Re: Turkey Point Units 3 and 4
 Docket Nos. 50-250 and 50-251
 Response to NRC Request for Additional Information Regarding
 Extended Power Uprate License Amendment Request No. 205 and
 Reactor Systems Issues

RESPONSE TO NRC RAI REGARDING EPU LAR NO. 205
AND SRXB REACTOR SYSTEMS ISSUES

Figure a1: PCT for All Rods

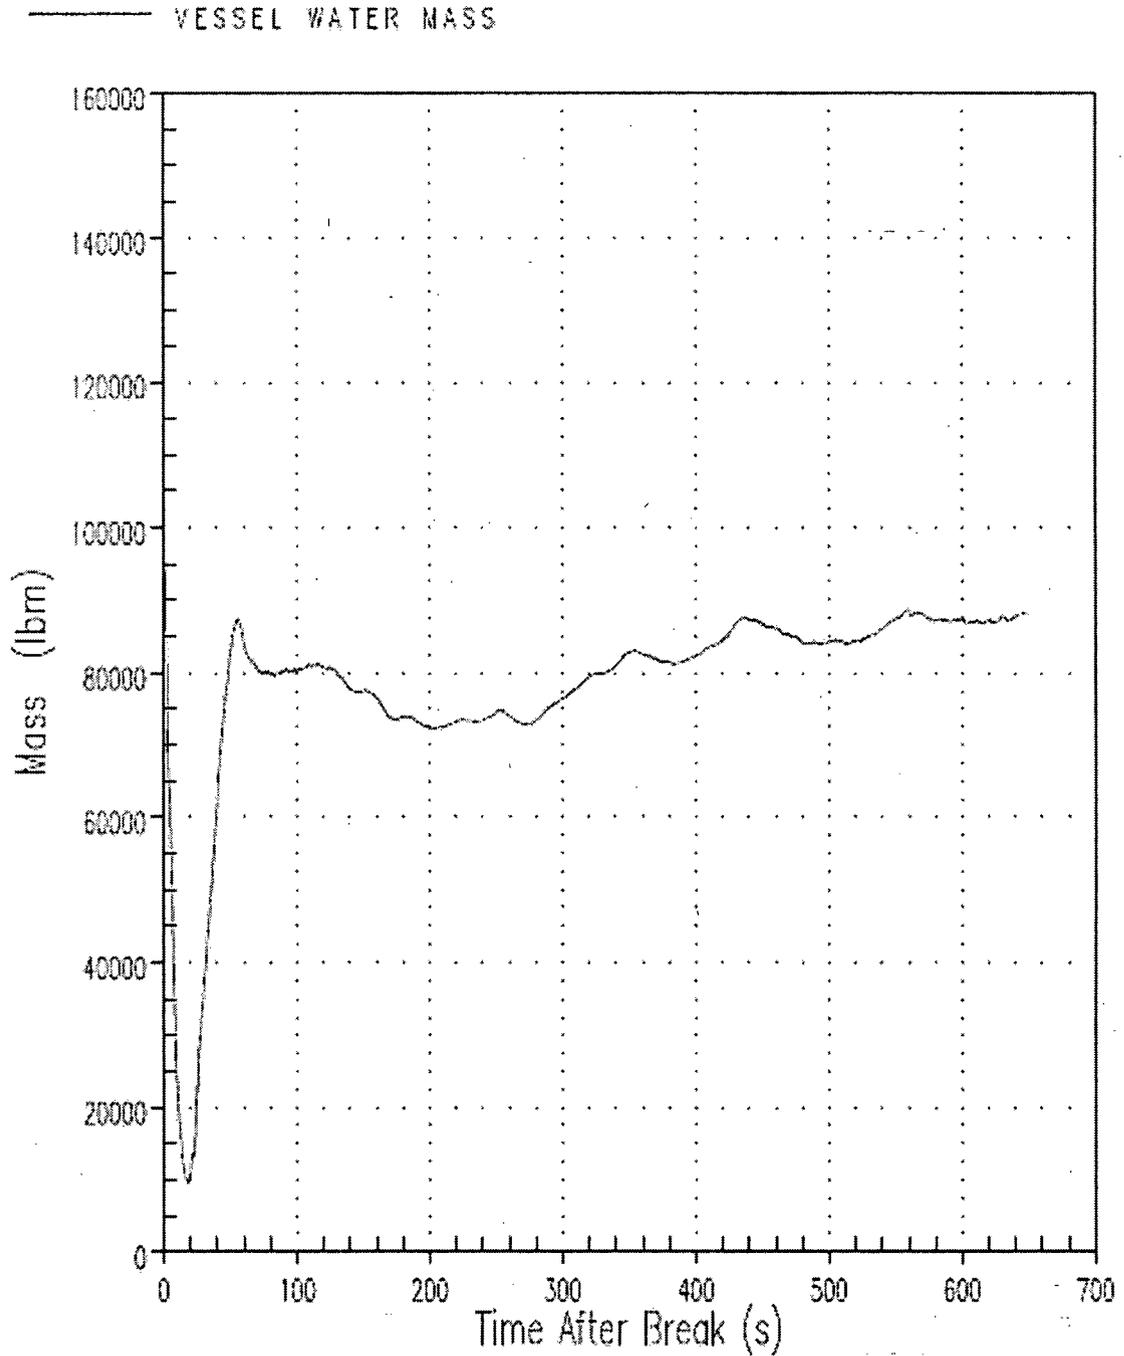
SRXB-1.3.35 Explain the cause of the abrupt drop in low-power channel liquid level observable at approximately 350 seconds in Figure 2.8.5.6.3.2-13.

As shown in LR Table 2.8.5.6.3.2-3, Hot Rod PCT is calculated to occur at approximately 40 seconds, and as shown in LR Figure 2.8.5.6.3.2-15, the core is fully quenched at approximately 310 seconds. Therefore, the abrupt drop in low-power channel liquid level observed at approximately 350 seconds is well after the PCT is calculated and all rods have quenched.

To confirm that the core liquid levels continue to increase and all rods remain quenched after 350 seconds, the limiting PCT transient was re-run with the transient time extended another 300 seconds. From Figure a1, it can be observed that all rods remain quenched, and vessel water mass (Figure a2), lower plenum collapsed liquid level (Figure a3) and core liquid levels (Figure a4) keep increasing and are well above that required for the core to remain covered by a two-phase mixture with all fuel rods quenched as boiling continues. In addition, from Figure a5, it can be observed that the liquid level in the downcomer becomes stable after about 450 seconds.
